UNITED STATES PATENT AND TRADEMARK OFFICE

APPLICATION NO.	FILING DATE	FIRST NAMED INVENTOR	ATTORNEY DOCKET NO.	CONFIRMATION NO.
10/539,597	06/17/2005	Georges Cholet	CHOLET2	4791

Office Action Summary	Application No.	Applicant(s)	
	10/539,597	CHOLET ET AL.	
	Examiner	Art Unit	
	MICHAEL LE BOULLUEC	2856

Figure 1. (Ohtsuki et al.) Chamber 1A detailing Hopper Section

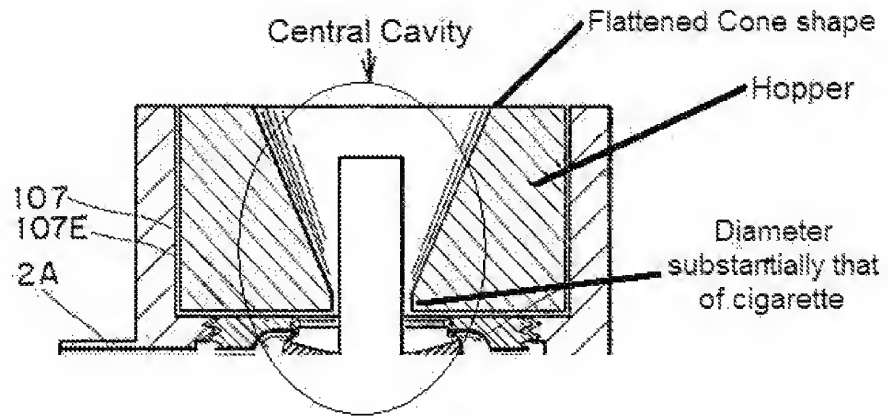
- wherein the sample-holder comprises firstly, a cylindrical structure made of three tubular parts (1A/1B/1C) assembled onto one another, namely:
 - a first part (1A) comprising a hopper (refer to figure 1 below) whose central coaxial cavity comprises a part of flattened cone shape (refer to figure 1 below) followed by a cylindrical part whose diameter is substantially that of the cigarette, the lower part of this hopper comprising an iris diaphragm (107E) as recited in claim 5;

Figure 2. (Ohtsuki et al.) Chamber 1B detailing two respective ends of a tube

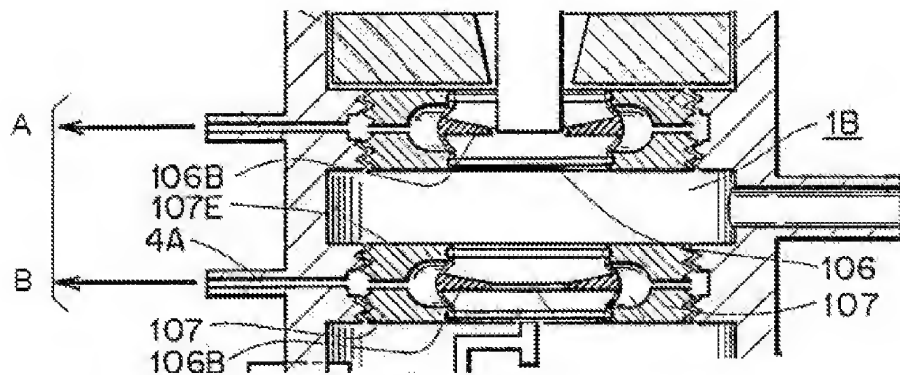
- a second part (1B) consisting of two respective ends of a tube in dielectric material fit with gas-tight assembly, the inner diameter of this tube being slightly larger than the cigarette diameter as recited in claim 5; (**NOTE:** Ohtsuki et al. do not specifically disclose a tube of dielectric material fit however, the instant application uses a separate tube of dielectric material covering a portion of the cigarette within the cavity while being tested. Ohtsuki et al. use sample supporting members (106) of dielectric material to support the cigarette within the cylindrical gas-tight assembly exposing more of the cigarette to the air flow during ventilation testing allowing a highly accurate measurement of ventilation characteristics (col. 2, lines 51-57). Furthermore, Ohtsuki et al. disclose that a support contacting the cigarette by face-contact makes it practically impossible to obtain a highly accurate measurement value (col. 2, lines 35-47). Lastly, the instant disclosure has not stated the criticality of the tube, except that it supports the cigarette in the device during testing. Therefore, since the tube of the instant disclosure and the claims only support the cigarette, the sample supporting

members of Ohtsuki et al. are the functional equivalent and meet the structural limitation used in supporting the cigarette within the gas-tight assembly).
